1	5/9/24	New pkg layout Lots 217 & 17, Changes in response to BETA-Town of Franklin on Plan Set dtd 3/15/24.
---	--------	---

DEVELOPMENT PLAN
 PROPOSED PARKING LOT
 19 Cottage Street
 FOR
 James A. Colace/Abbruzzi Realty Trust
 55 Court Street
 Franklin, MA 02038

DATE: March 15, 2024
 DRAWN BY: S. Dunbar
 PLAN NO: 24-01

SEDIMENT & EROSION CONTROL PLAN

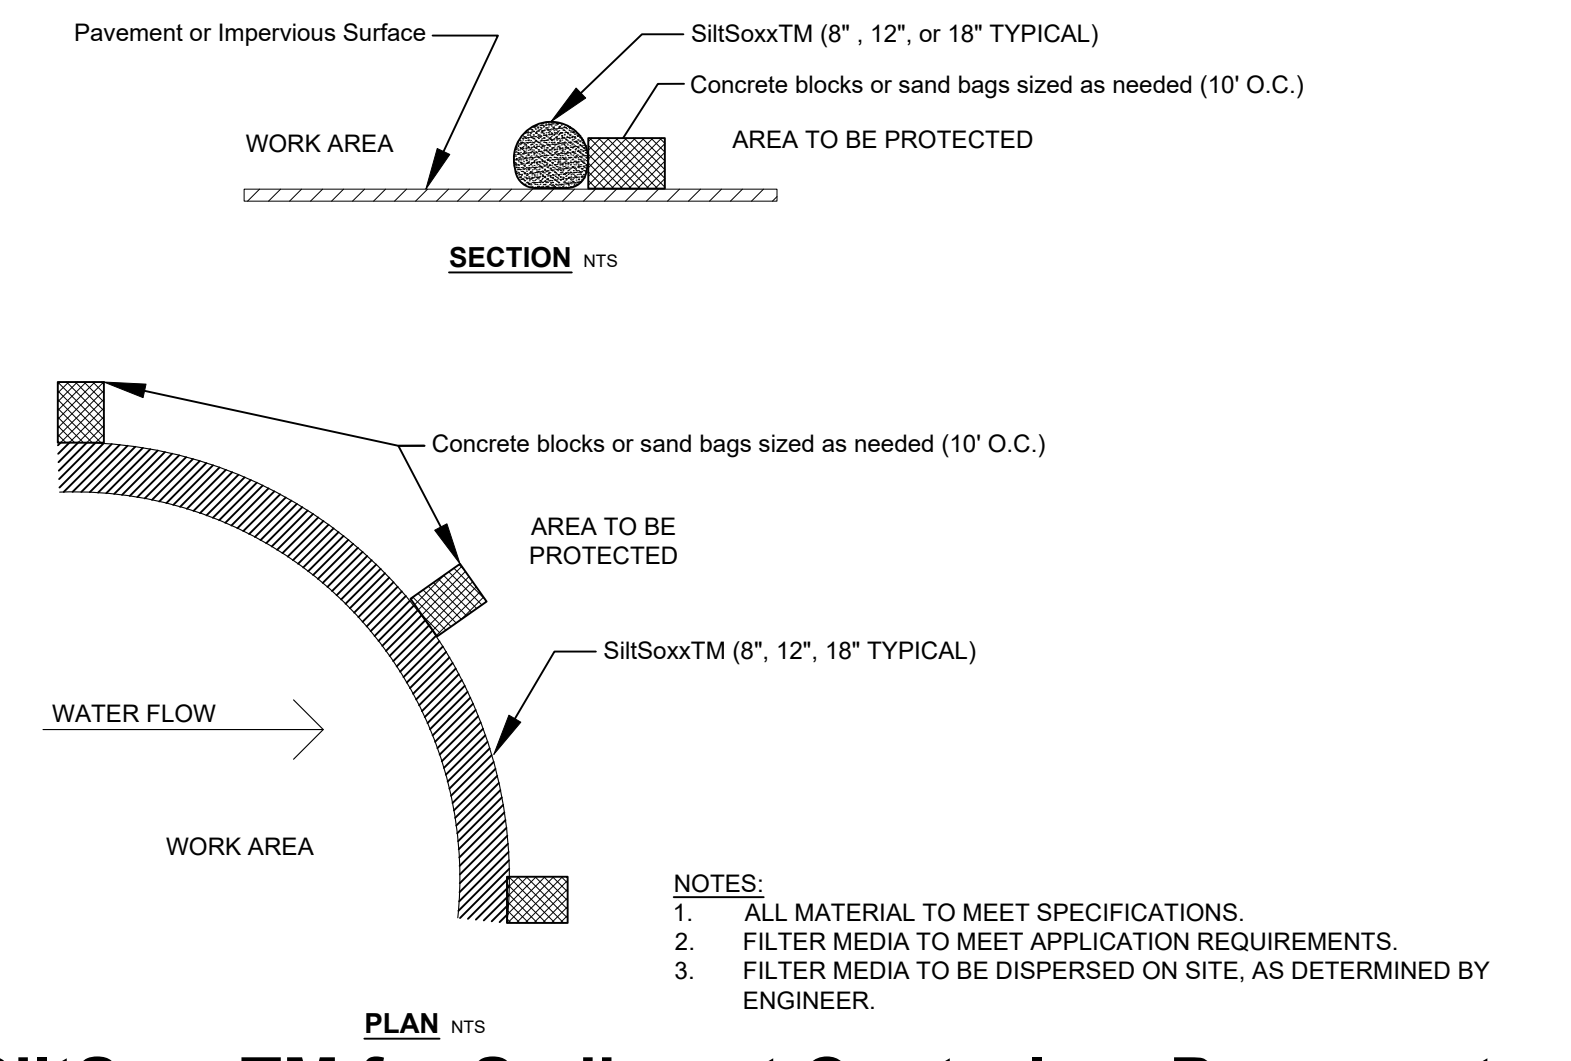
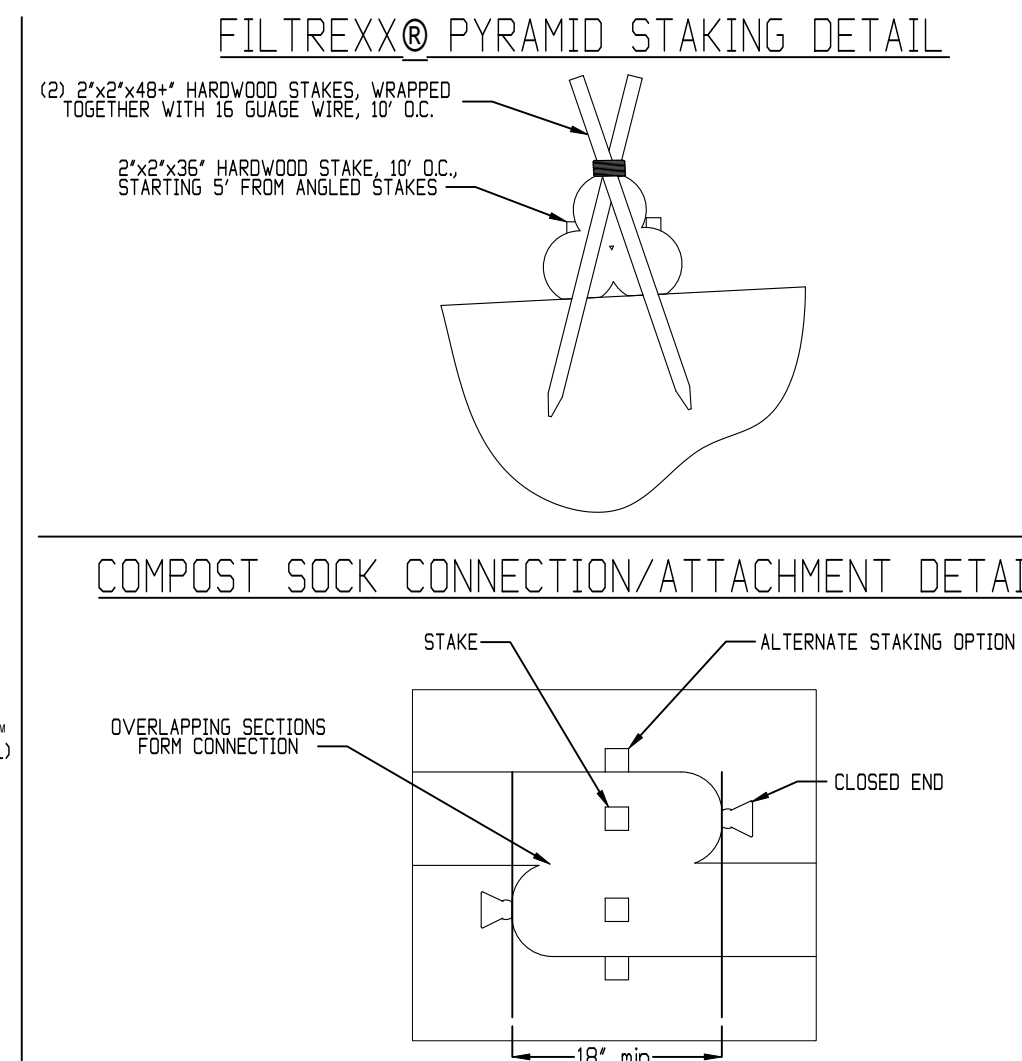
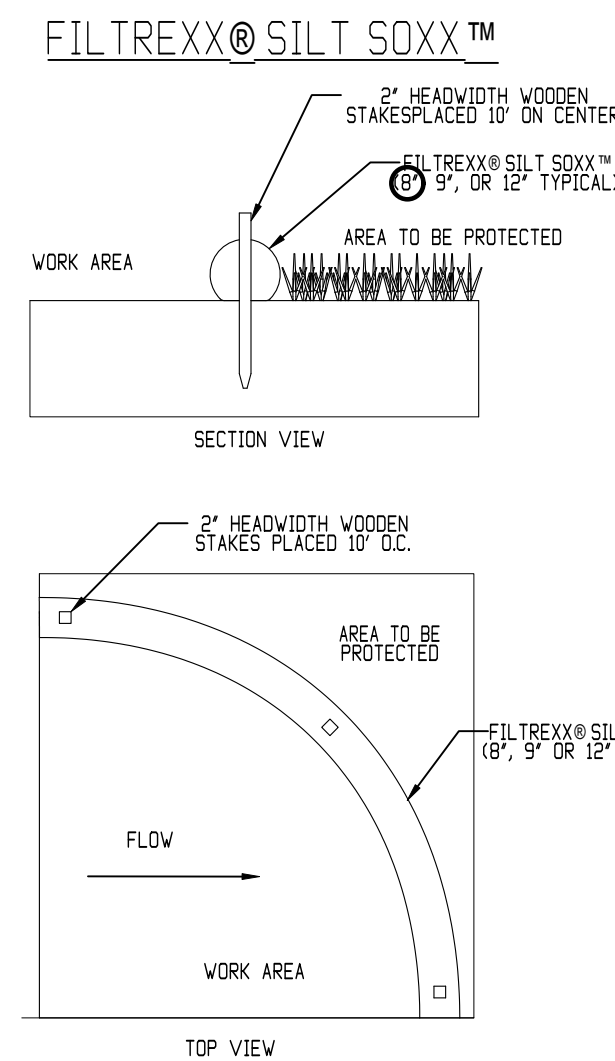
REVISIONS	
1	5/9/24 Added anti-tracking pad and proposed material storage areas based on comments on the 3/15 submission.

- Anti-tracking pad at construction entrance shall be constructed with 2' stone MADOT M2.01.1 or approved equal underlain by MIRAFL 140N filter fabric or approved equal.

PHOTOMETRIC PLAN
NTS

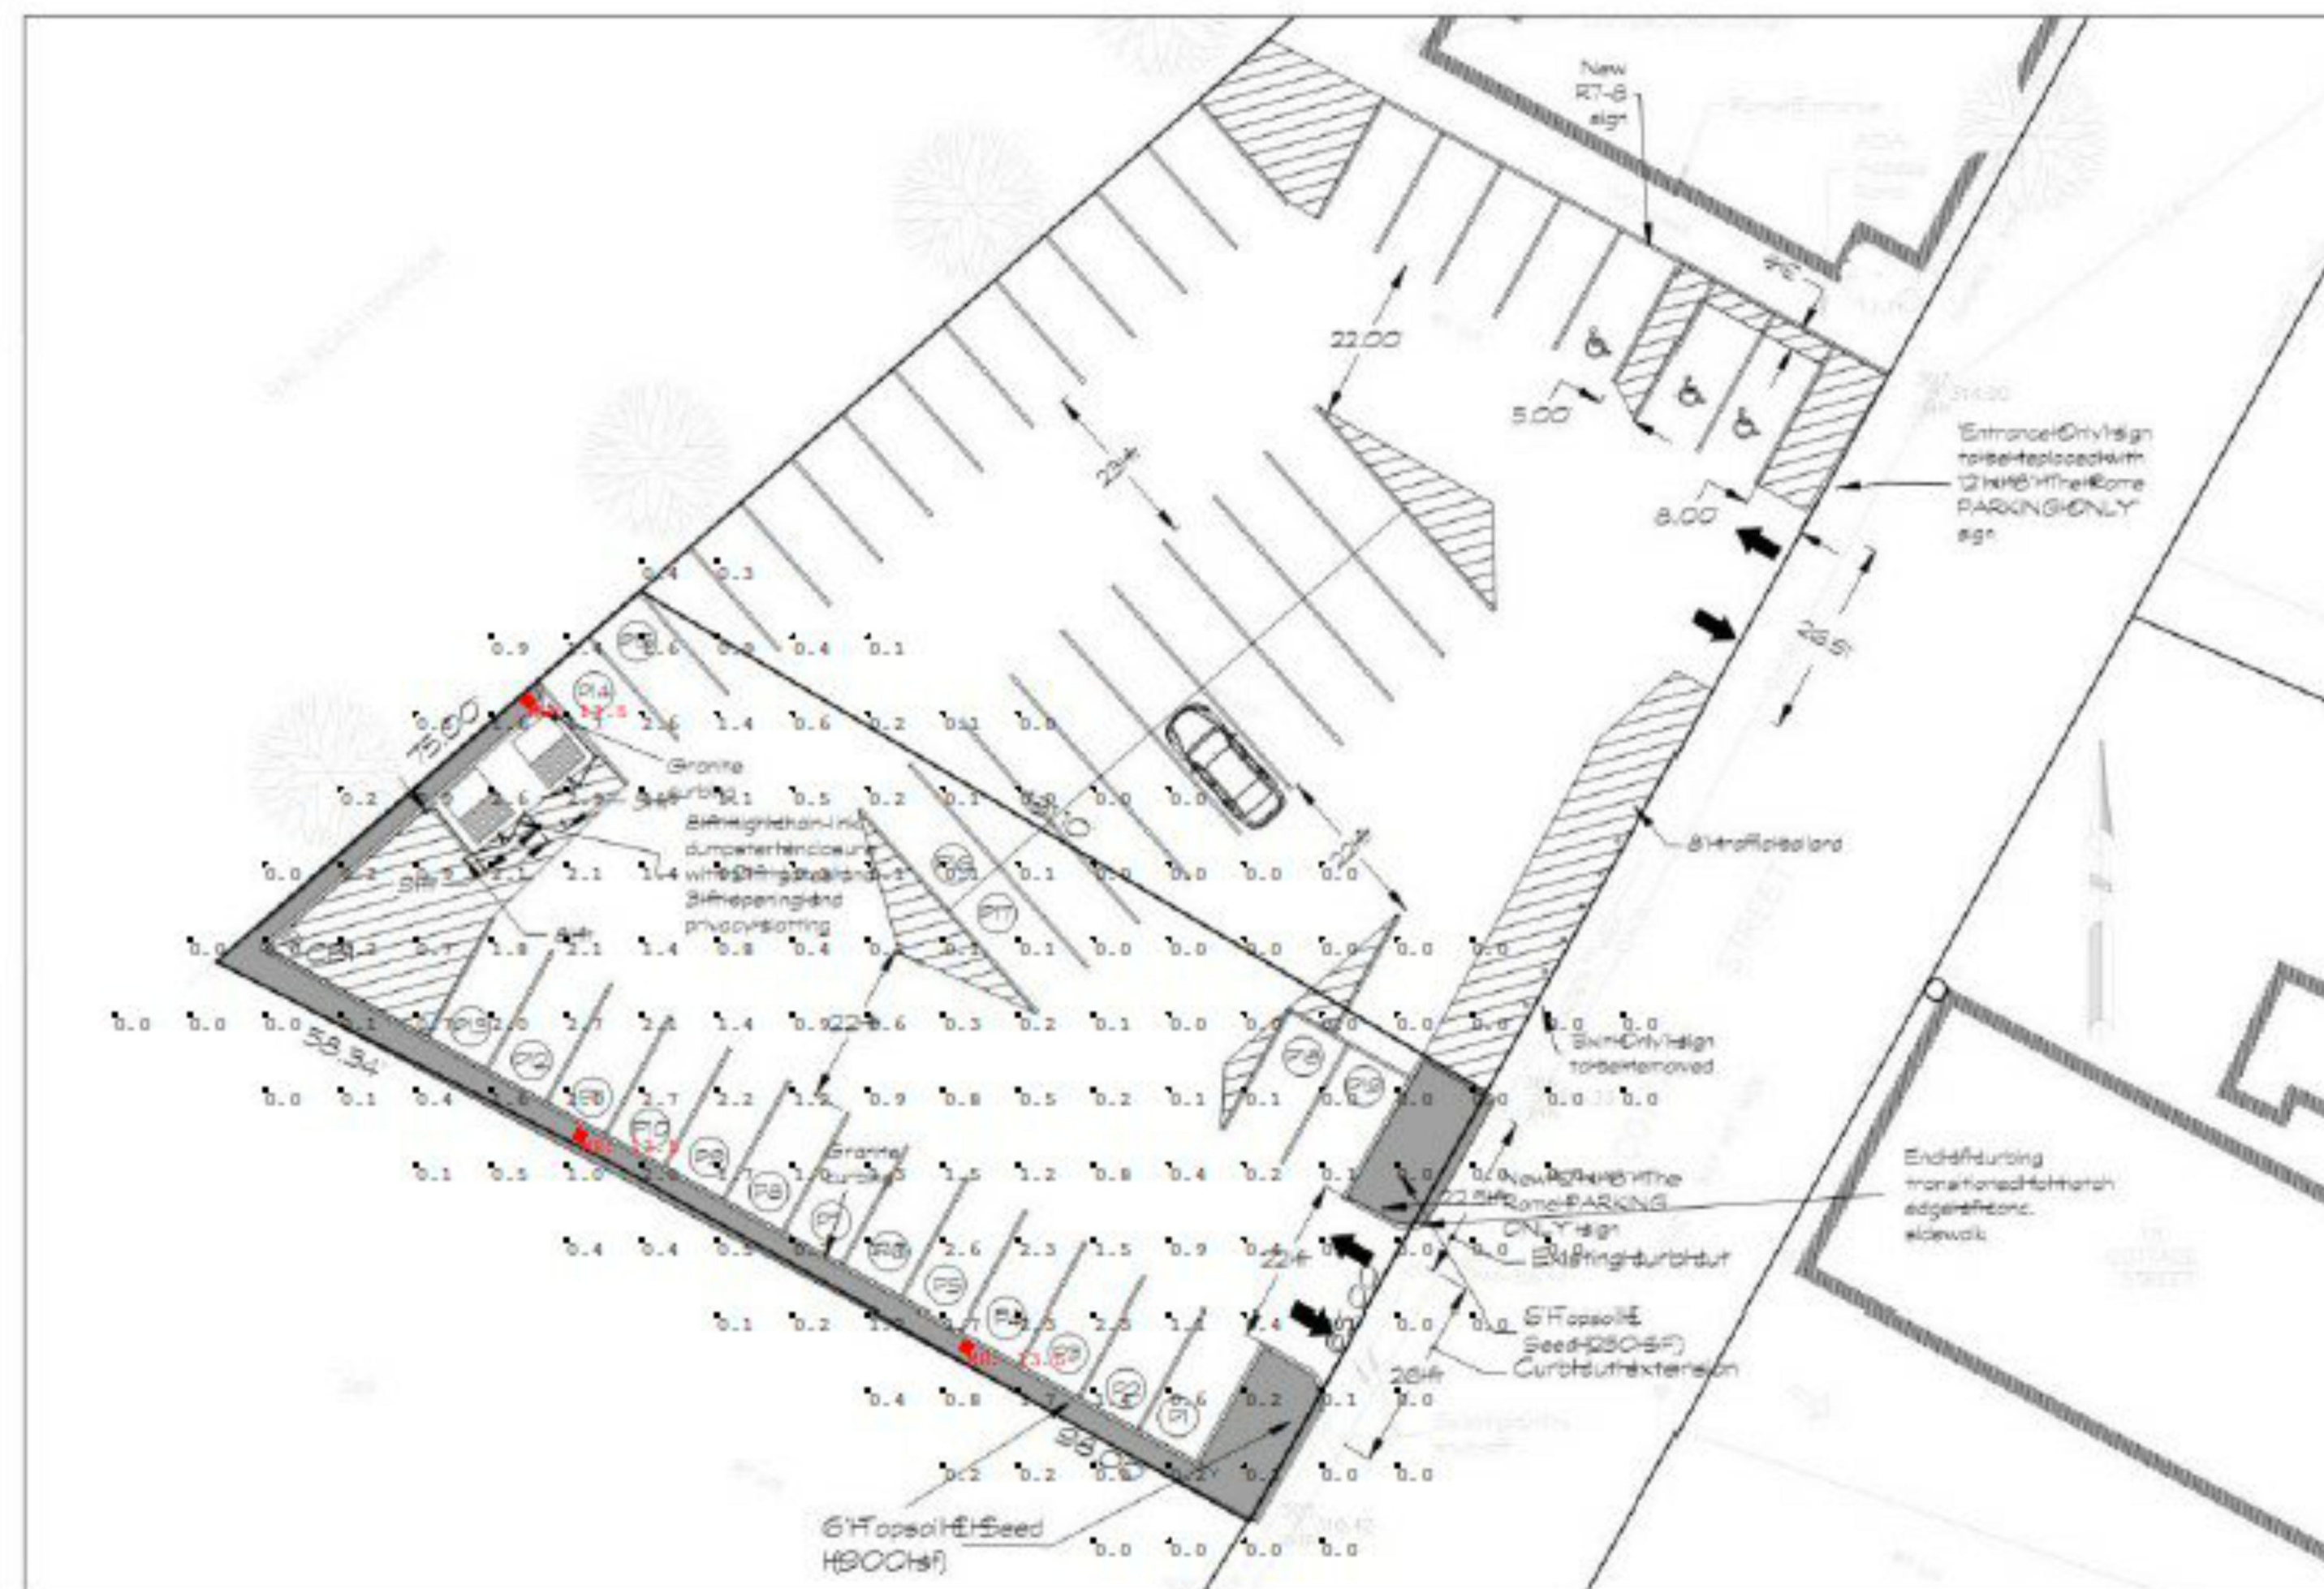
REVISIONS		
1	5/9/24	New pkg layout Lots 217 & 17; Luminaire height changed to 13.5 ft.
